SUNDRY NOTICES AND REPORTS ON WELLS

2. NAME OF OPERATOR
TEXACO EXPLORATION AND PRODUCTION INC.

8. FARM OR LEASE NAME
LYDIA RENTZ

9. WELL NO.
10

DRILLING CONTROL CONDITION II-3000 PSI WP

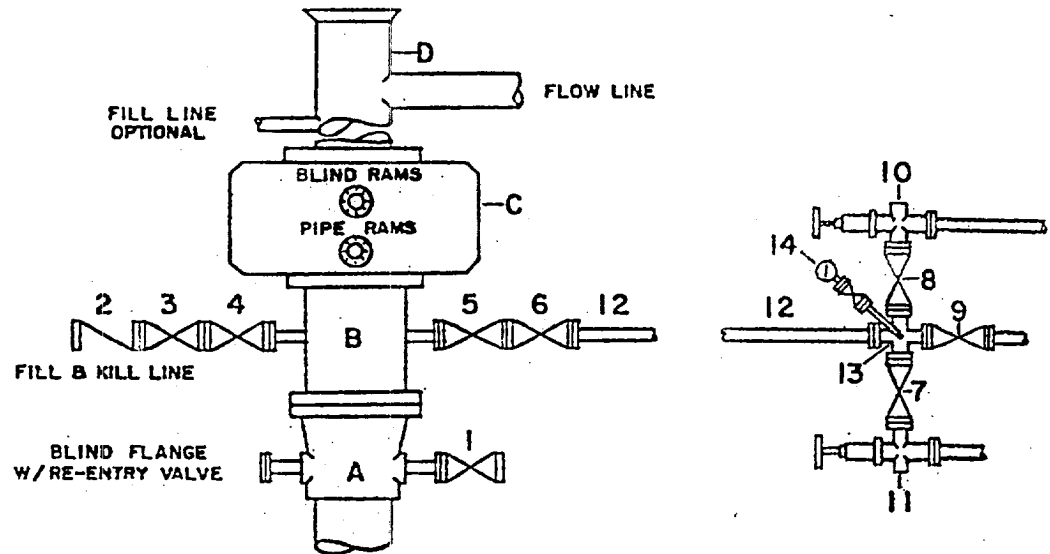
UPON FURTHER REVIEW OF THIS AREA, IT HAS BEEN DETERMINED THAT AN ANNULAR BOP IS NOT NEEDED AS ORIGINALLY SUBMITTED WITH THE APD. TEXACO RESPECTFULLY REQUESTS THAT THE MINIMUM BOP REQUIREMENTS FOR THIS WELL BE MODIFIED TO ONLY A 3000 psig WORKING PRESSURE DOUBLE RAM PREVENTER AS PER THE ATTACHED SCHEMATIC.
